# **Pearl Place Buildings I & 2**

**ADDENDUM II**

**September 22, 2006**

**Pearl Place**  
**Buildings 1 & 2**  
Portland, Maine

**A5.2**

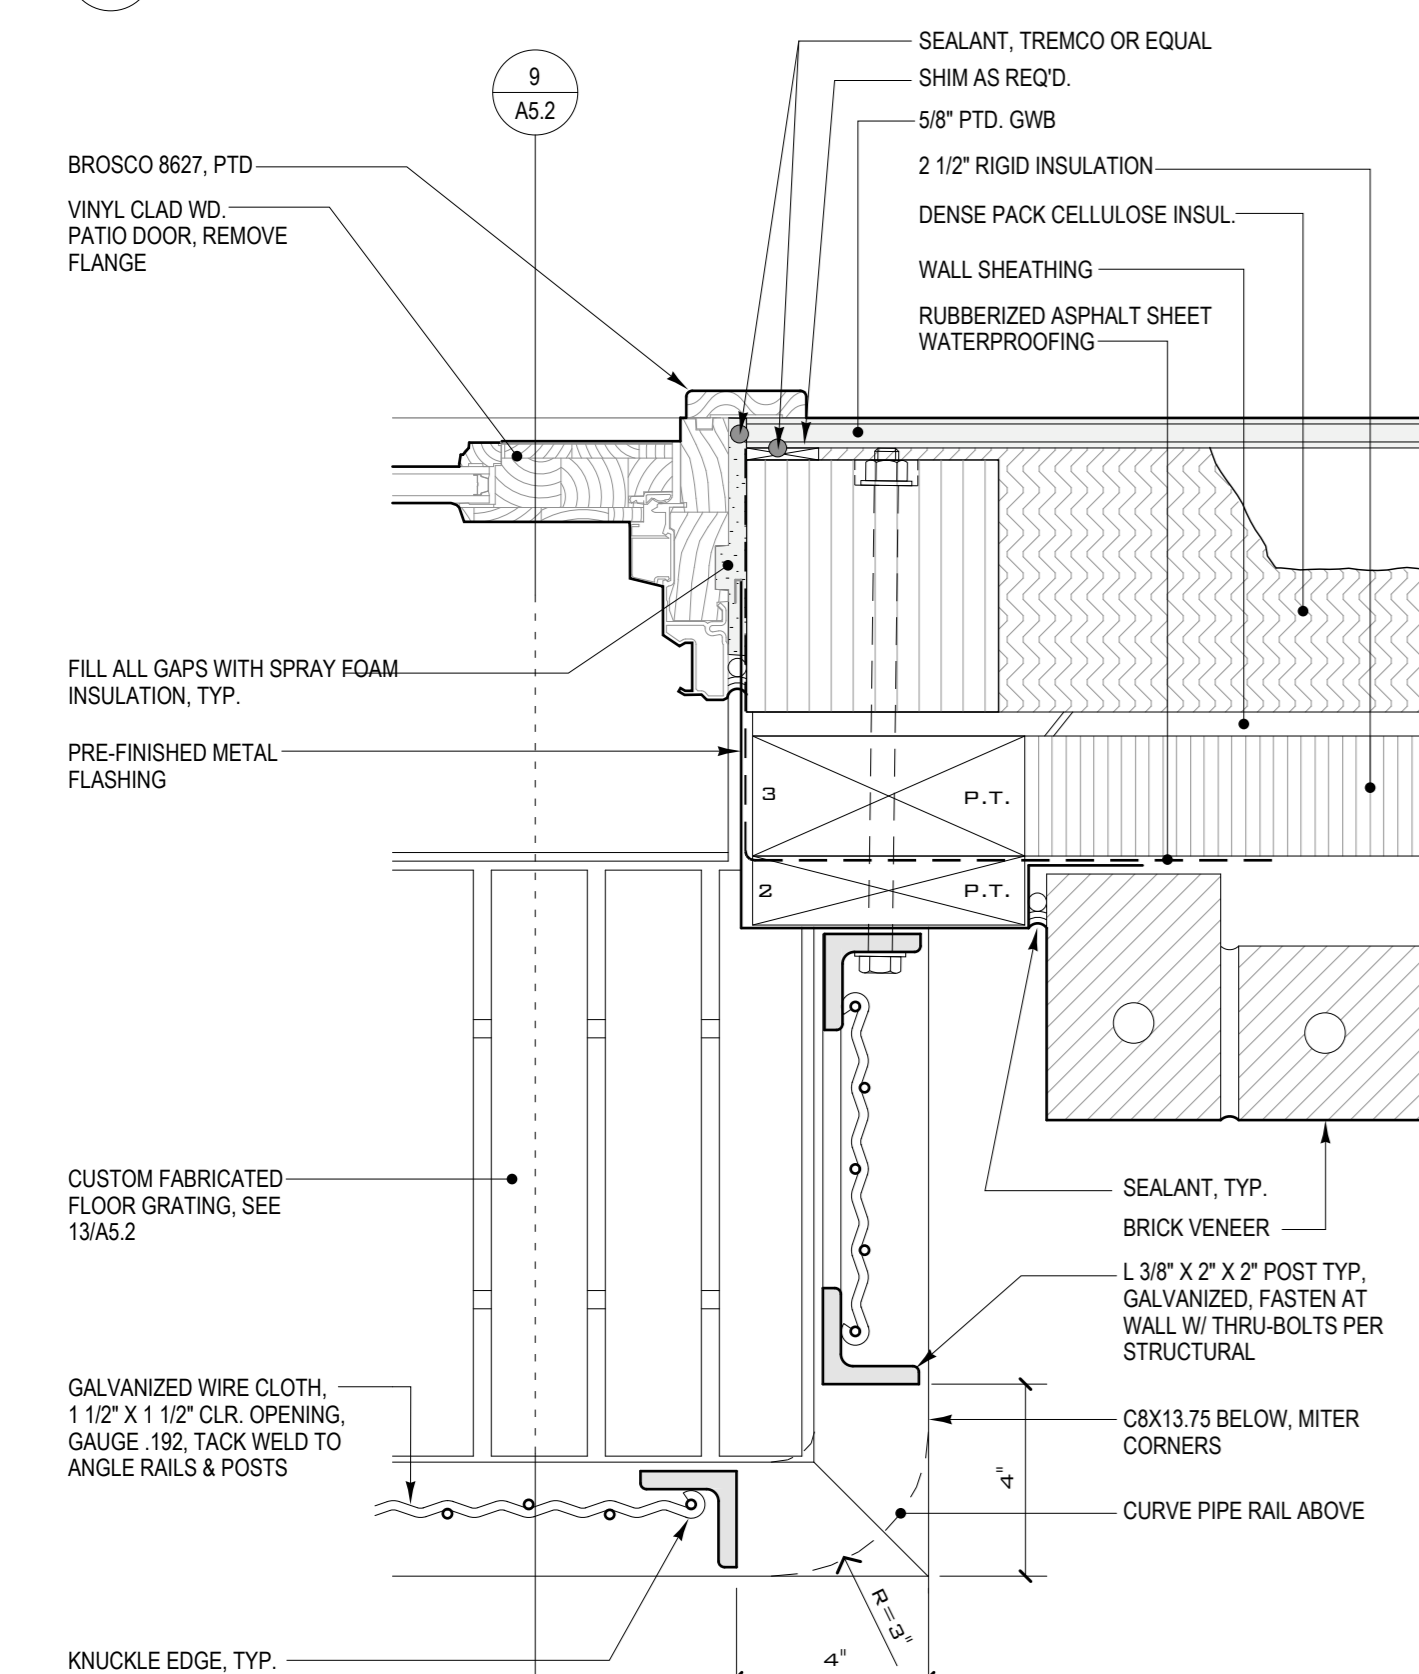
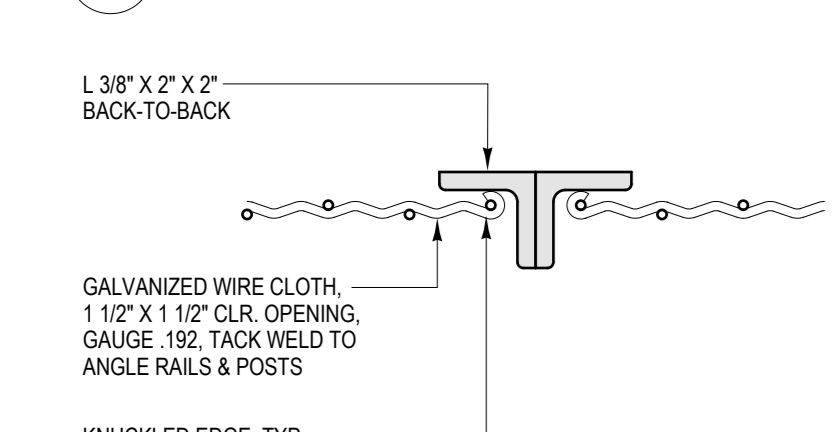
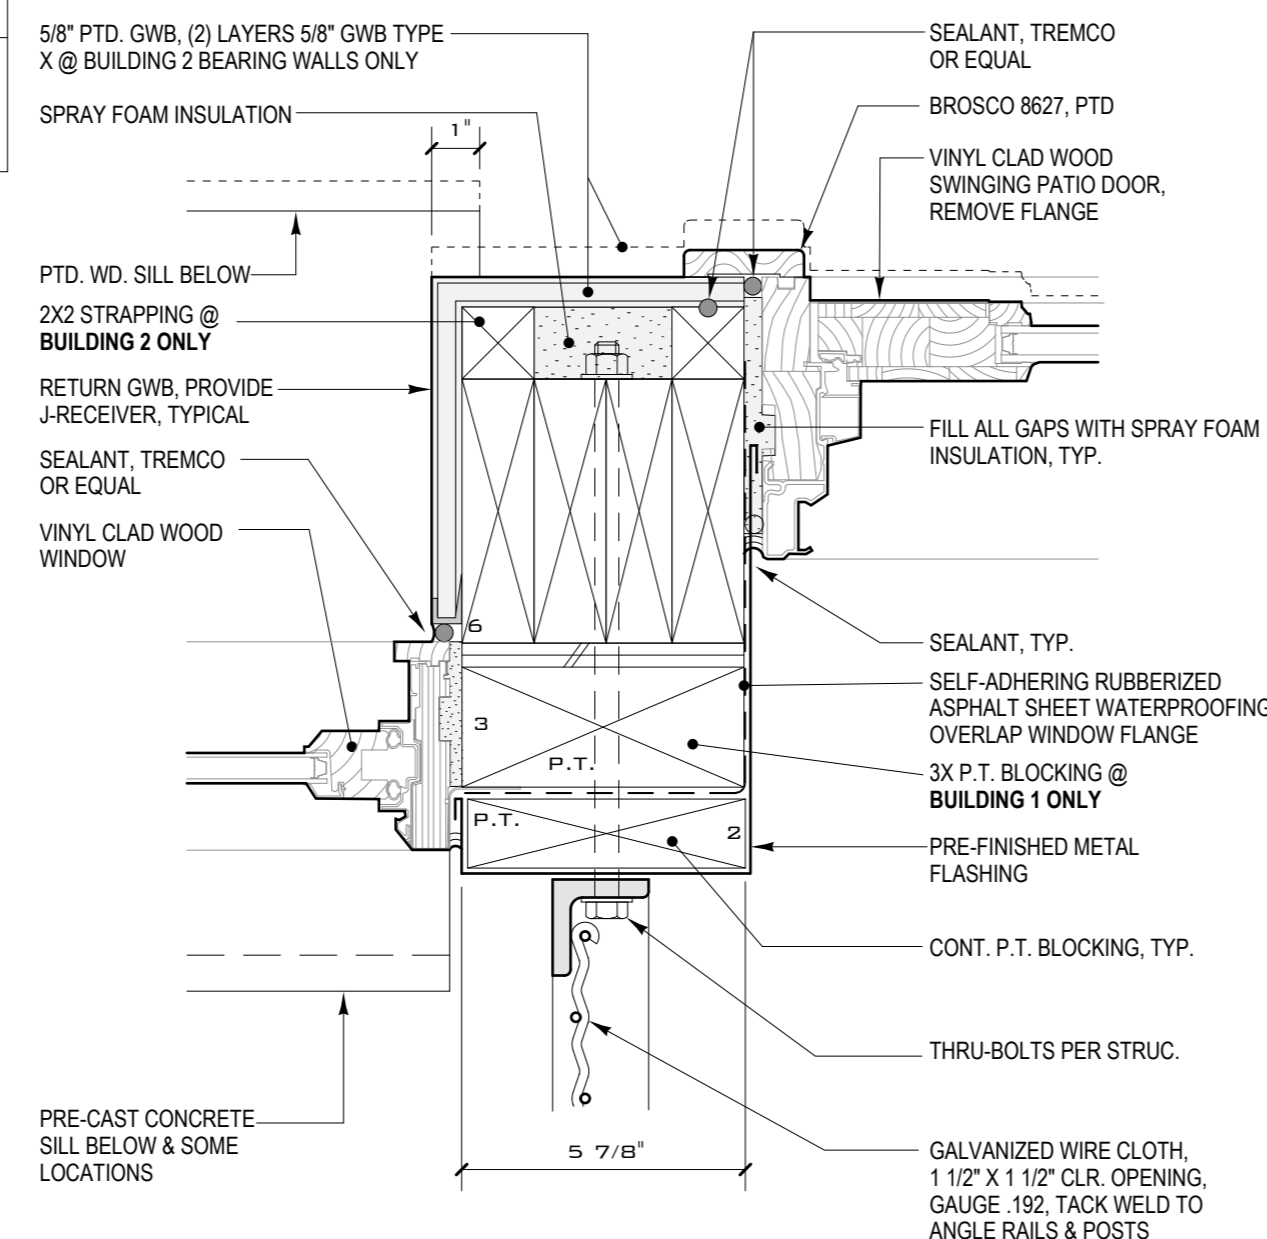
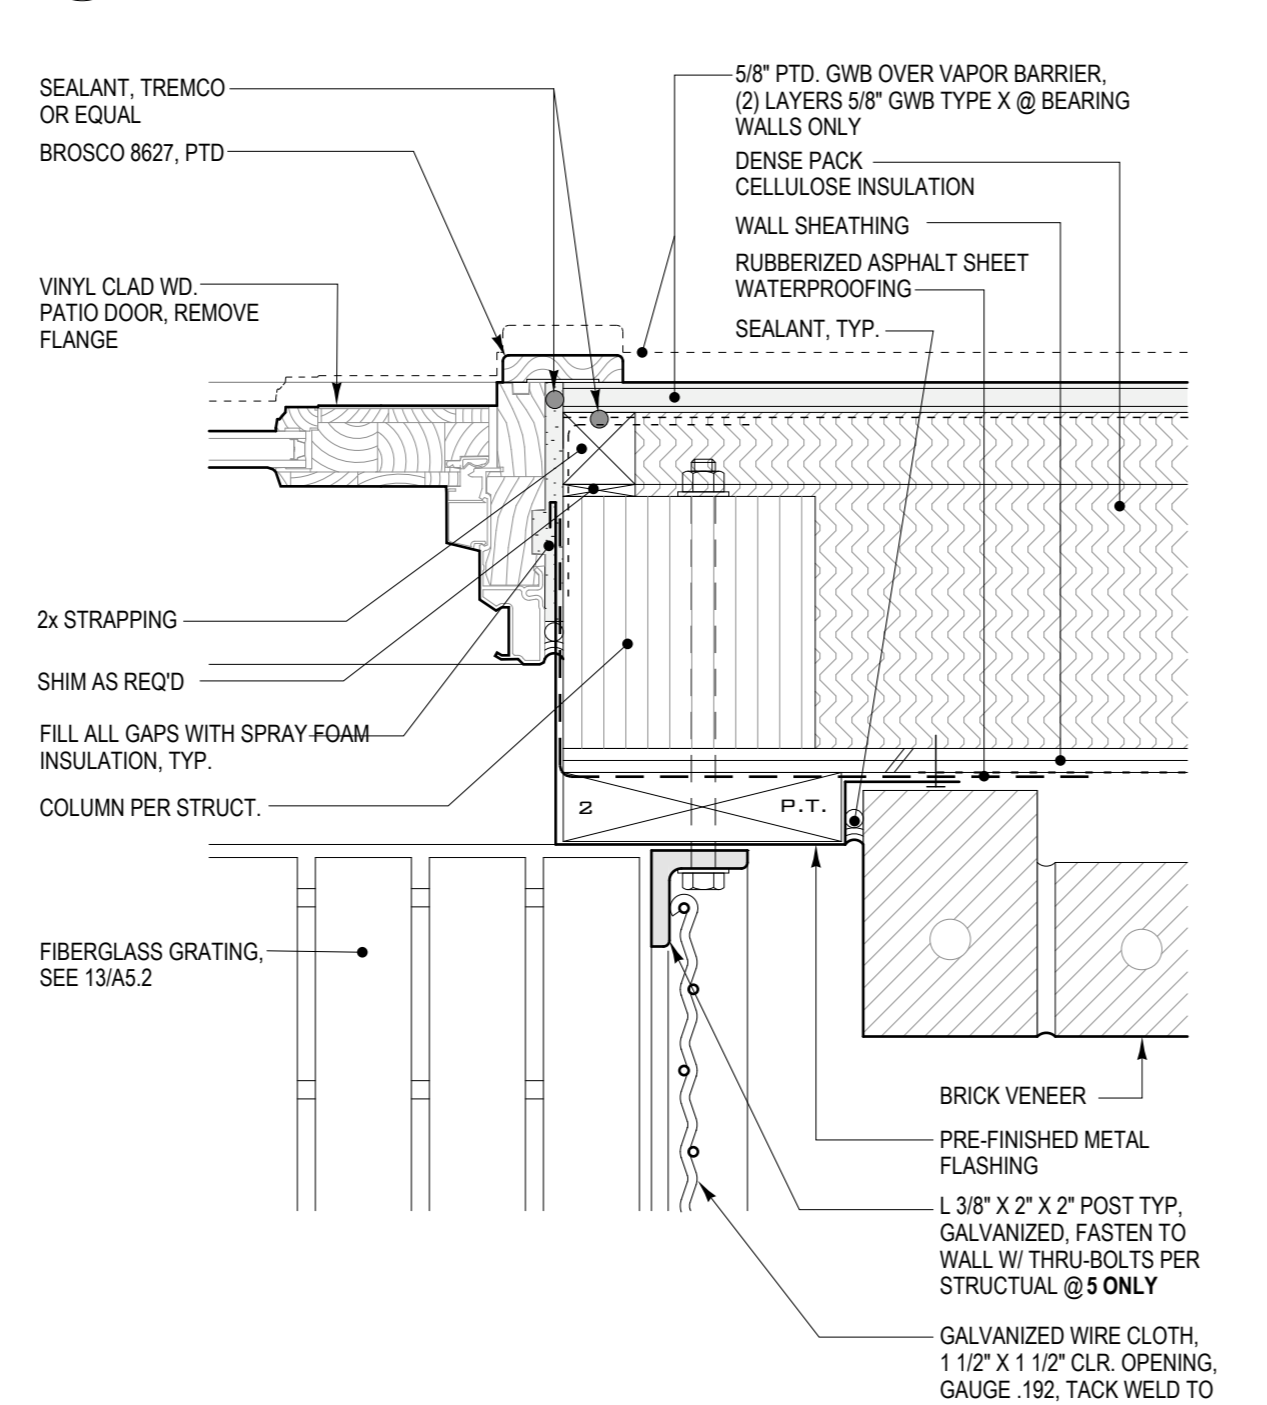
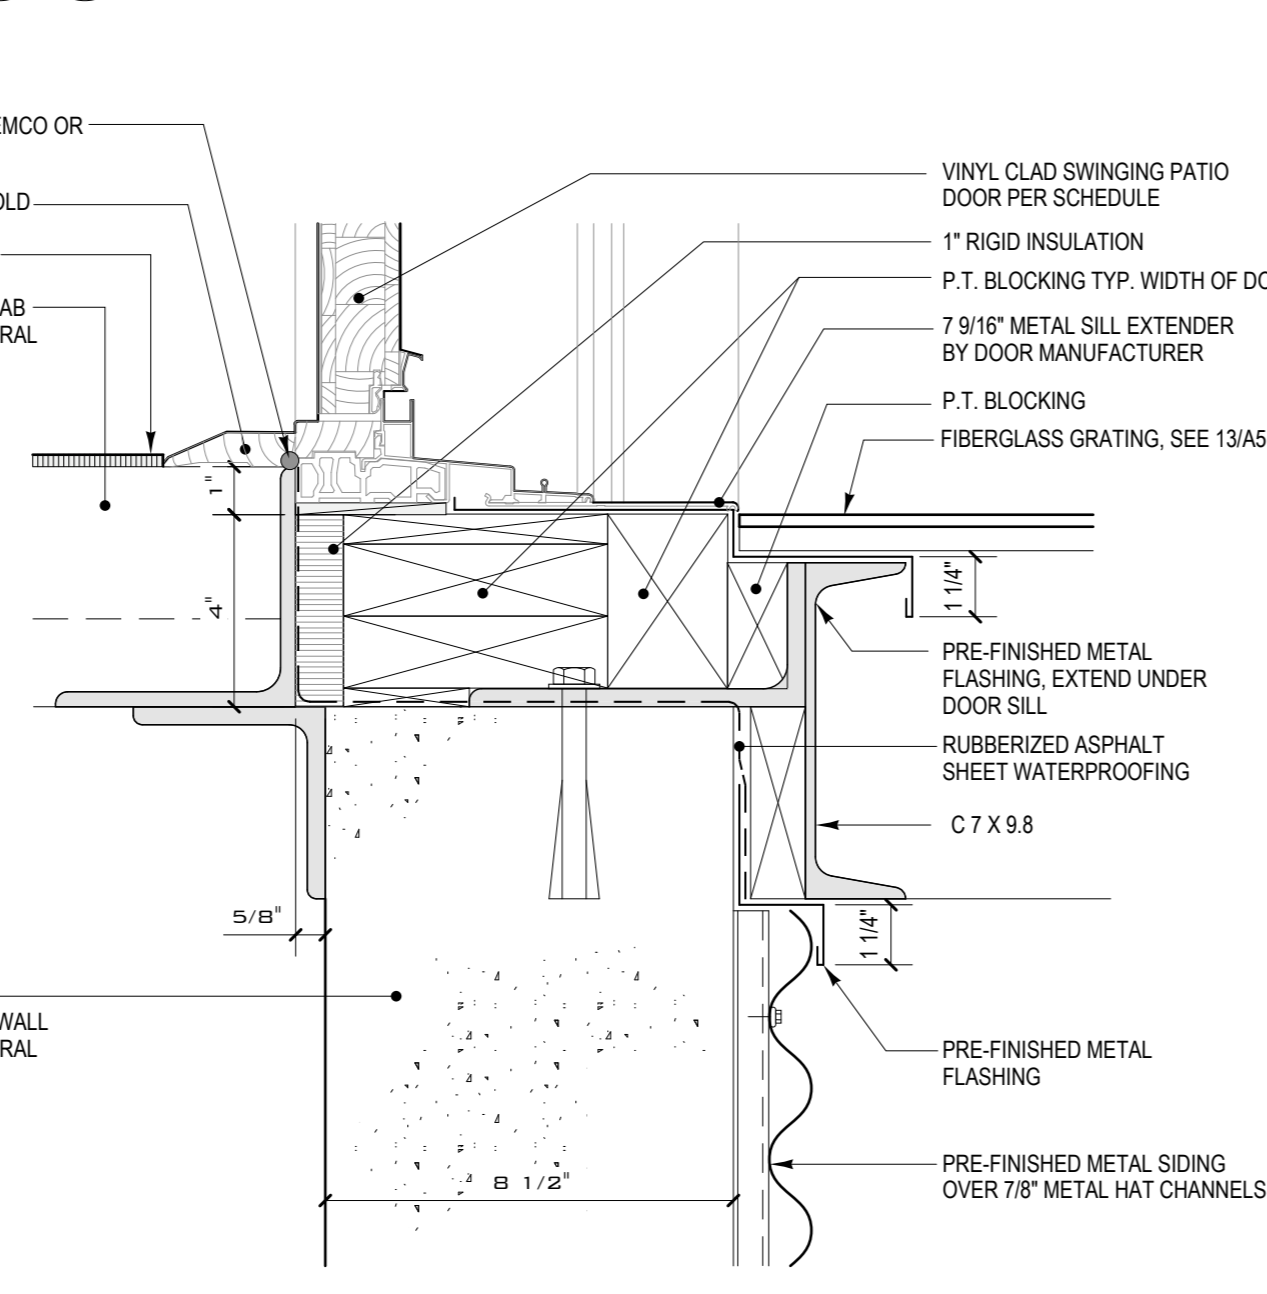
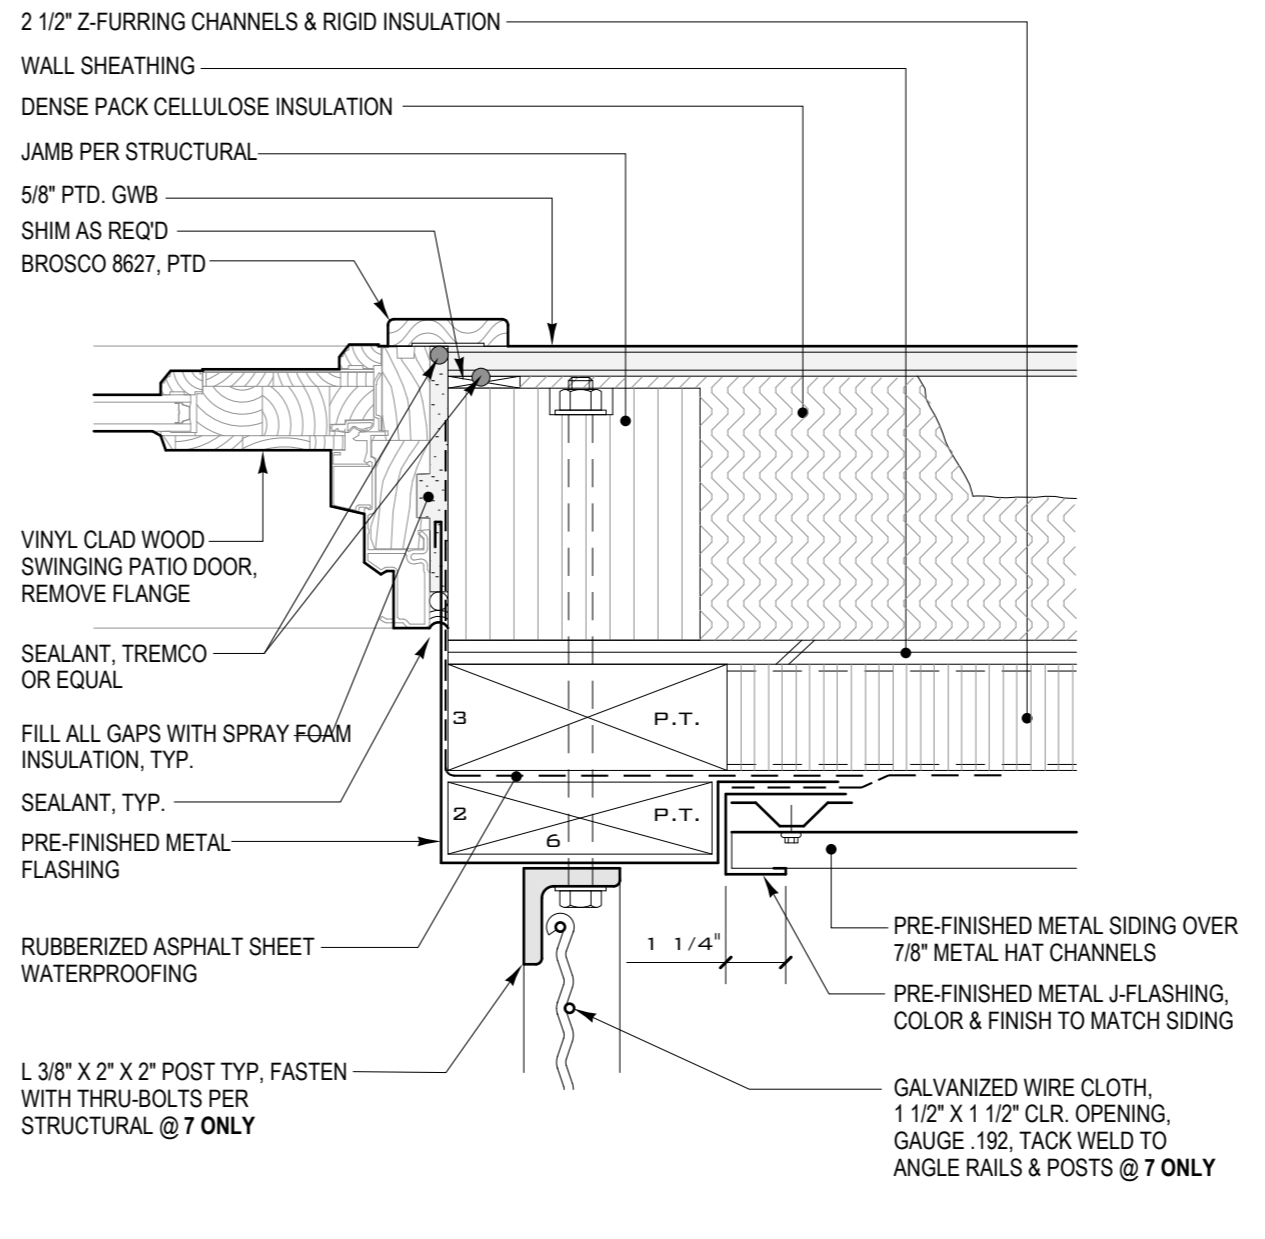
Q: General Note on A5.1 says to paint all exposed steel. Details 10, 12, and 13 on A5.1 indicate the steel mesh to be galvanized and so does the spec. But this present a field problem that you would have cold galvanized the tack welds on the mesh to the rail and then mask all mesh to paint the rail. The detail balcony on A5.2 indicates the frame and mesh to be galvanized. What is the correct finish?

A: All exposed steel components in the buildings are to be shop fabricated and welded before galvanizing, then galvanized, primed in shop with Primergalv and then painted with two coats as specified by section 09900, see Specification for Addendum 2 for further details.
